The proposal is subject to the Official Community Plan's Development Permit Area guidelines for Watercourse and Streamside Protection (DPA 1), Natural Hazard Lands (DPA 2), and to the rainwater management provisions of the Subdivision, Works and Services Bylaw.

RELEVANT TOWN BYLAWS

Figure 2 SPEA of 5 m for East Fork Maple Brook

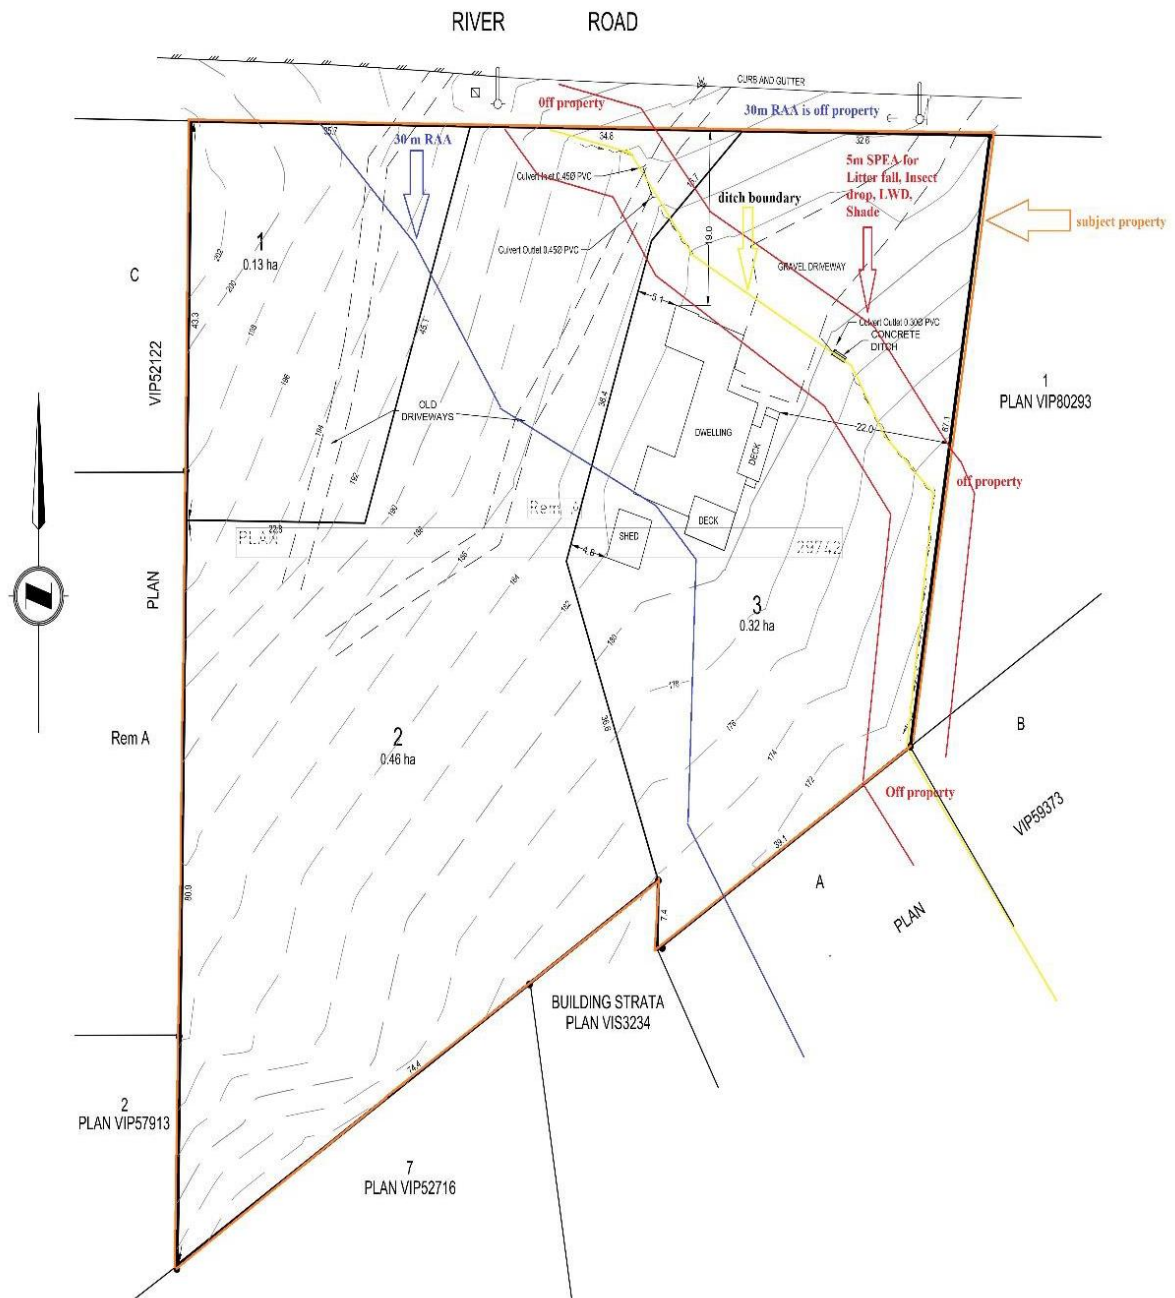
The subject property contains an ephemeral non-fish bearing watercourse named East Fork Maple Brook. Swordfern Environmental (a.k.a. Bob Crandall) identifies a 5 m wide SPEA on each side of the watercourse for the purpose of litter fall, insect drop, and shade. This watercourse falls across proposed Lot 2 and Lot 3, which contains an existing dwelling.

The location and purpose of the 5 metre SPEA for the East Fork Maple Brook should be identified on the plan of subdivision.

- 1) The location and purpose of the 5 metre SPEA for the East Fork Maple Brook shall be identified on the plan of subdivision.
- 2) Identification of building envelopes in the plan of subdivision for Lots 1 and 2, including appropriate covenant text as may be required. No building envelope for a principal dwelling may be identified for the northern 45 metre portion of Lot 2, which is characterized by steep slopes.

Figure 3 'No Build' steep slope zone identified in red colour

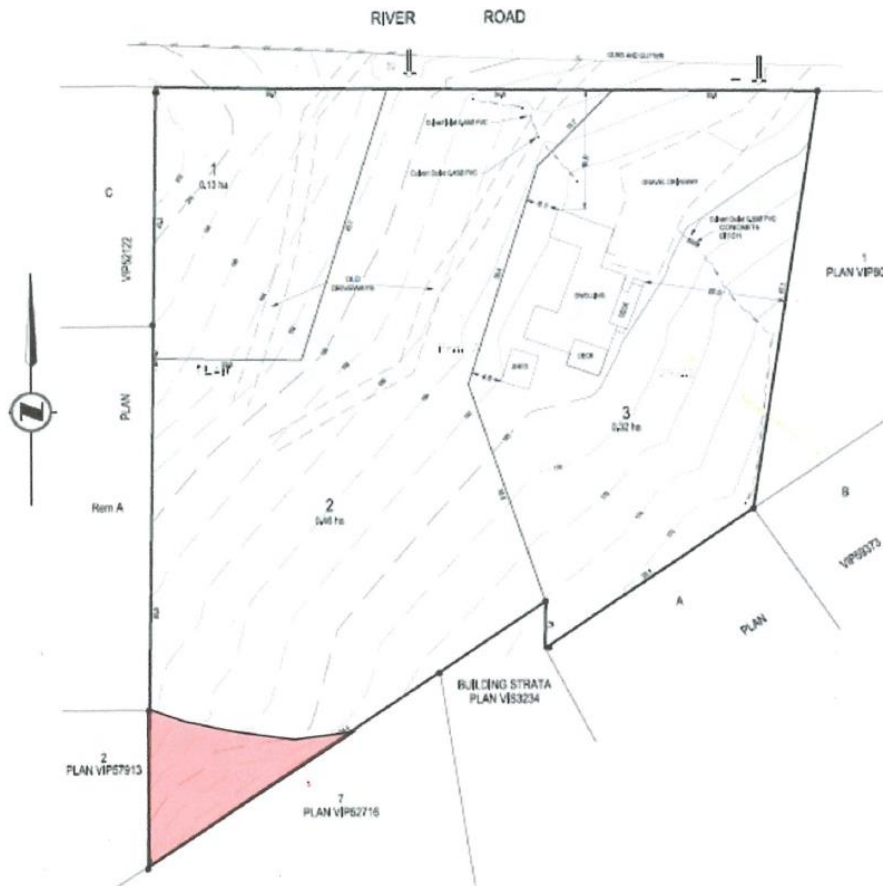
With respect to small-scale localized landslide the assessment noted that future development may exacerbate instability and increase hazard probability. Accordingly, the report recommends the following:

1. For safe areas (all areas outside the 'no build' zone), approval with covenant and siting requirements.
2. No development within and a 15 metre setback from the steep slope 'no build' zone identified in figure 3, below.
3. Retain mature coniferous trees along the property's southern boundaries where slopes are greater than 30%.

- 3) No development may occur within the steep slope 'no build' zone identified for Lot 2 in Figure 3 and within a 15 metre setback from the zone. This shall be established by covenant in the plan of subdivision.
